BLAISE AD HAZOP

RMD-02-004

An interface HAZOP study was undertaken at BioConstruct's offices at Stockton-on-Tees, Teesside on 3rd June 2019, commencing on 4th June and being completed on 9th July, on the design of the proposed Anaerobic Digestion Facility for Crofthead.

This report details the findings of the HAZOP Study. The drawings used in the HAZOP study are found in the Drawings Section of this report and are based upon the following P&IDs:

REMOVE BURRS AND SHARP CORNERS EXCEPT AS STATED. IF IN DOUBT ASK. N/A DO NOT SCALE.

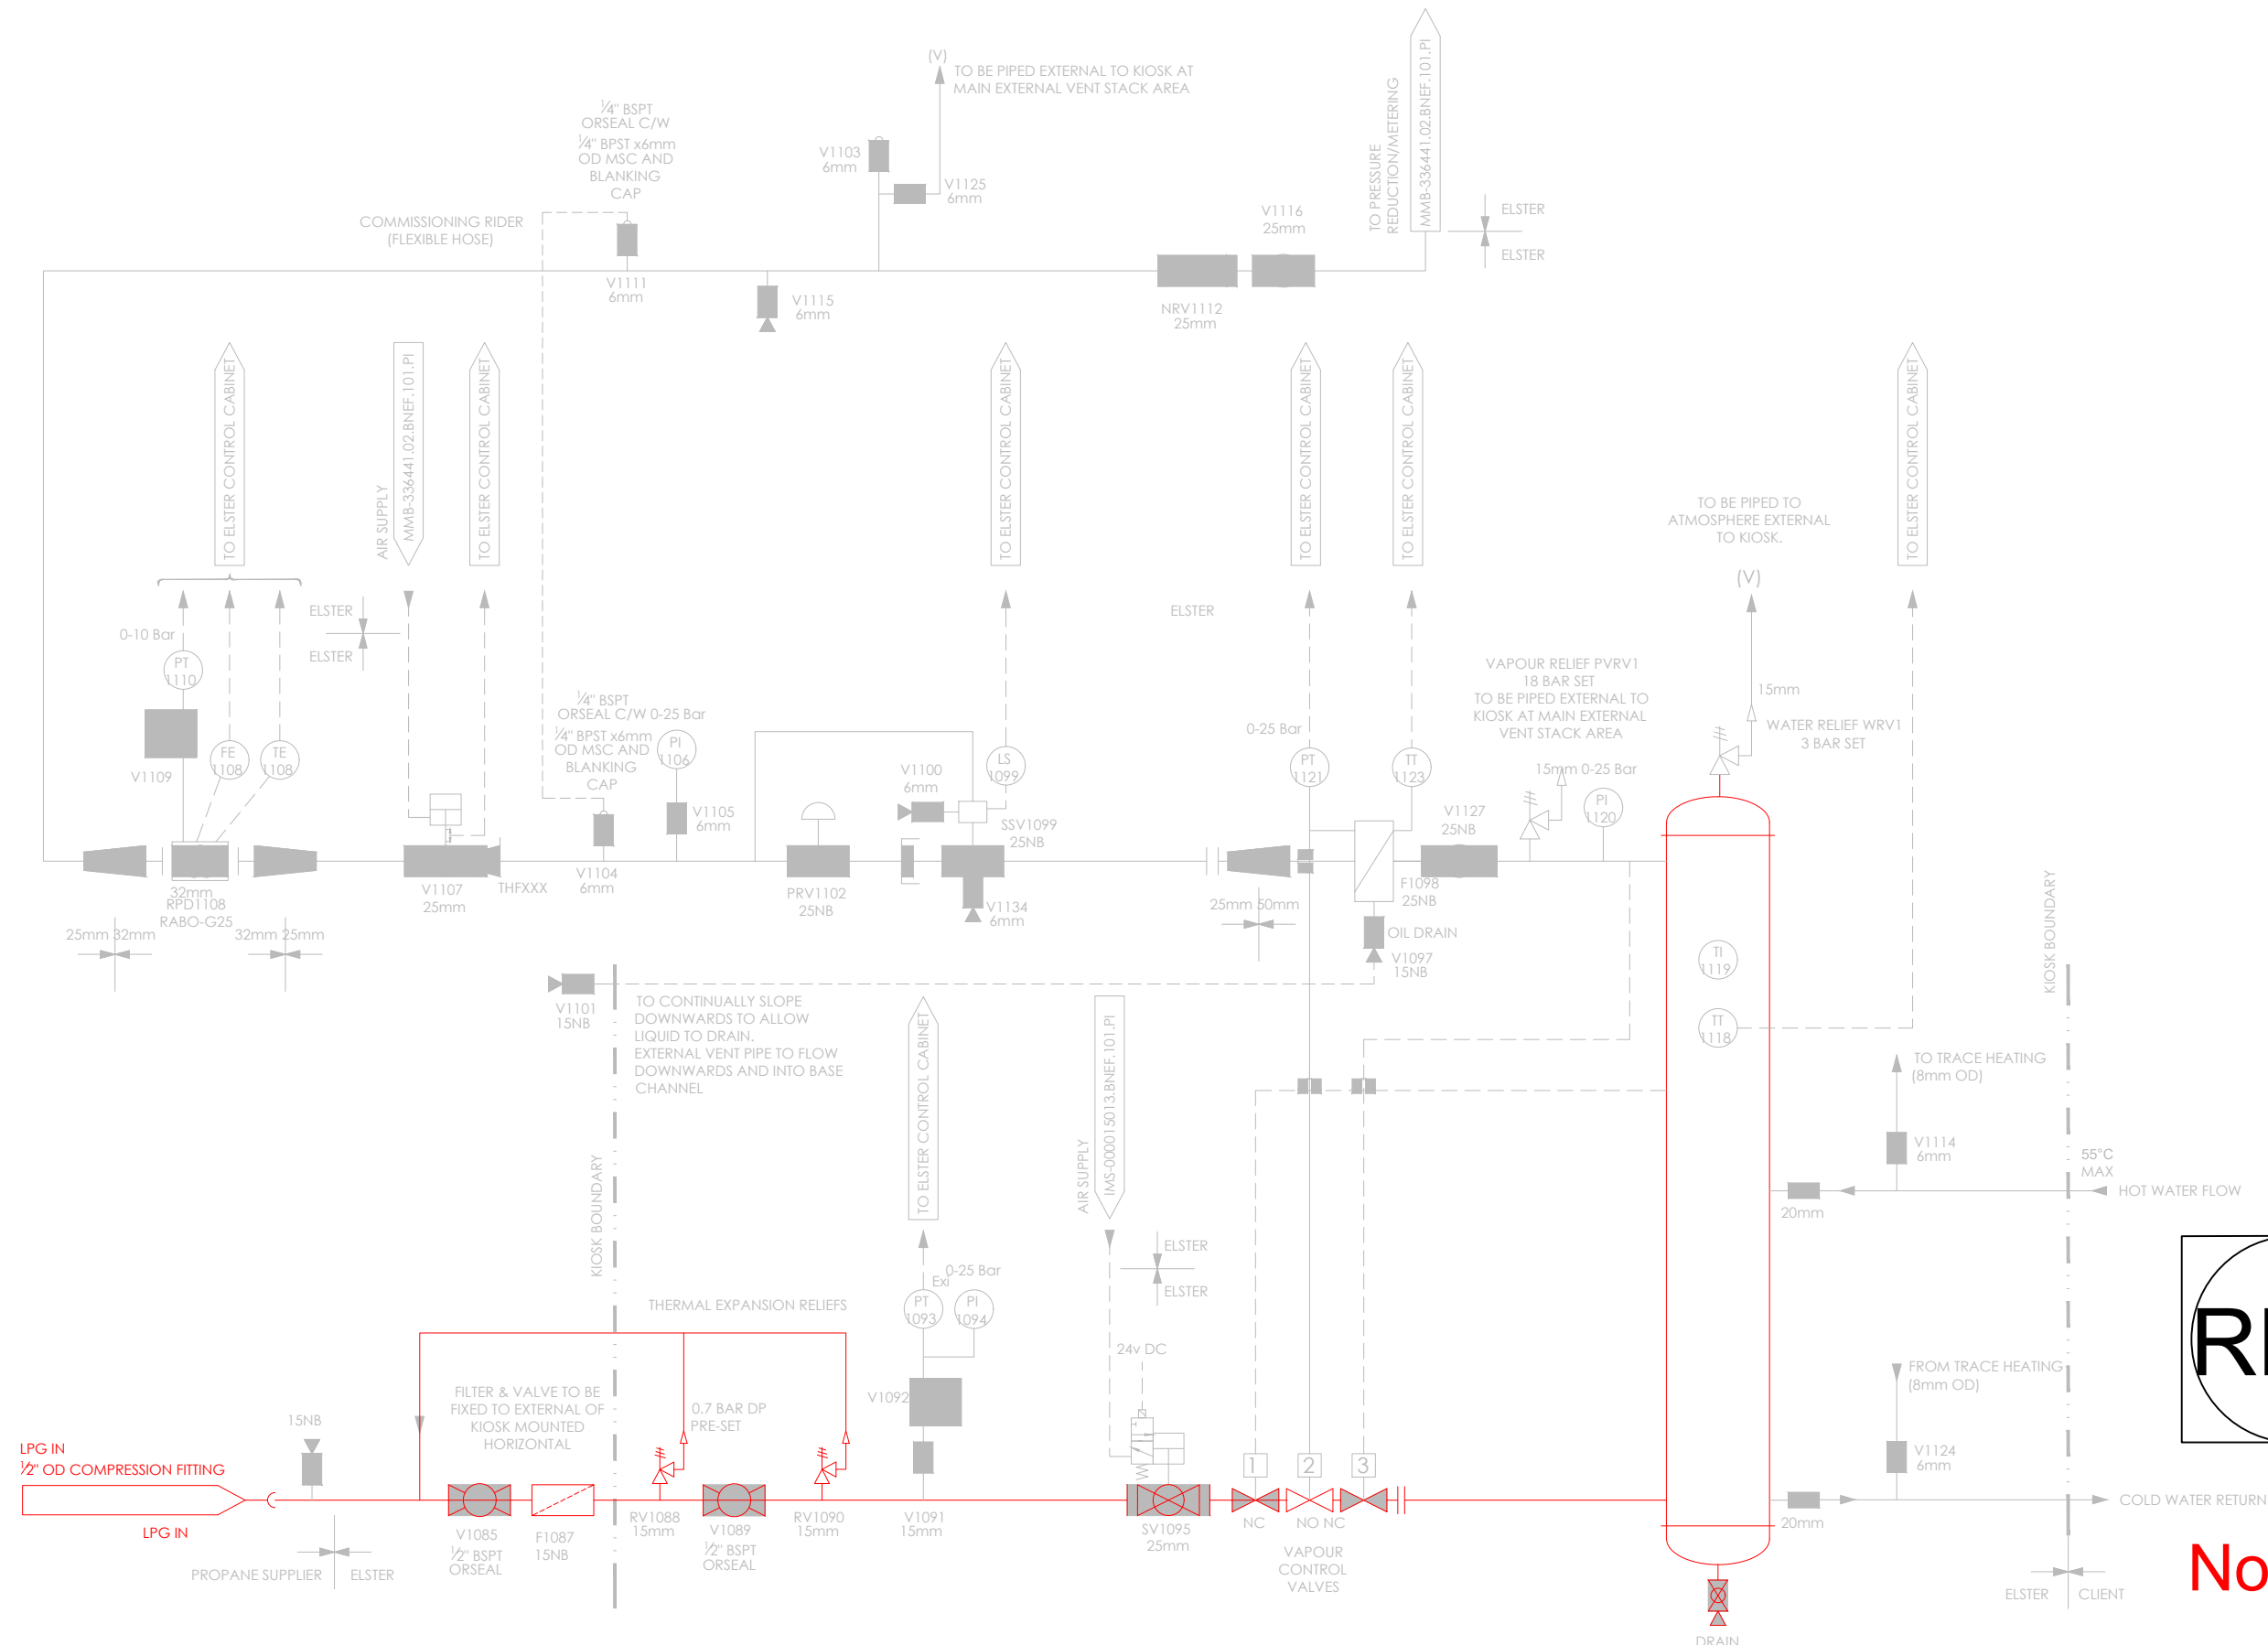
| ID/No. | Deviation | | No. | Possible Causes | Consequence | Safeguards | No. | Actions Required | Action Allocated to |
|--------|----------------|-------------|-------|--|---|--|---------|---|---------------------|
| 4.2 | More | Flow | 4.2.1 | Failure of spillback valve LV3008 | • Increase in pressure in propane line - increased fire and explosion risk | • Overpressure relief within Flogas system and GEU | | | |
| 4.3 | No | Flow | 4.3.1 | Failure of duty propane pump electrical mechanical failure | • Unable to propanate the biomethane resulting in reject | • Automatic start-up of standby pump on reduced pressure - on pump failure due to electrical failure there is a pump error signal. On low pressure if low pressure continues once standby pump operational both pumps will be shut-down an alarm signal is raised • Regular maintenance and inspection • Operator training | | | |
| | | | 4.3.2 | Manual valve LV 3014 /3017 closed when should be open normally open operator / commissioning / maintenance error | • Unable to propanate the biomethane resulting in reject | • Operator training • Pre-commissioning and post maintenance checks • Propane storage within separate secured compound | | | |
| 4.4 | Less | Temperature | 4.4.1 | Vaporiser malfunction electrical failure | • Inability to blend propane - failure to meet GSMR quality standards, biomethane to reject | • Regular maintenance and inspection • Alarms on the electrical breaker • Low temperature alarm on water and propane exit • Automatic valves 1 & 3 are closed until correct temperature achieved | | | |
| 4.5 | No | Flow | 4.5.1 | Tank runs dry | • Inability to blend propane - failure to meet GSMR quality standards, biomethane to reject | • Low flow alarm will shut-down GEU • Propane supply contract ensuring weekly top up of tanks • Level indication and telemetry on propane tanks will automatically trigger a delivery at 1/3 volume | | | |
| | | | 4.5.2 | Fractured propane line external to the GEU | • Loss of containment of propane and increased fire and explosion risk | • Low pressure alarm within GEU stops propane pumps | | | |
| | | | 4.5.3 | Propane line fracture within GEU | • Loss of containment of propane and increased fire and explosion risk | • Propane detection within GEU raises alarm • GEU rated ATEX zone 1 | | | |

| ID/No. | Deviation | | No. | Possible Causes | Consequence | Safeguards | No. | Actions Required | Action Allocated to |
|--------|----------------|-------------|-------|--|---|--|---------|---|---------------------|
| 4.1 | General Action | | | | | | 4.1.0.1 | Install manual isolation valve on propane inlet to GEU | Flogas |
| 4.6 | General Action | | | | | | 4.6.3.1 | Flogas to provide SRCPM with fire precaution requirements | Flogas |
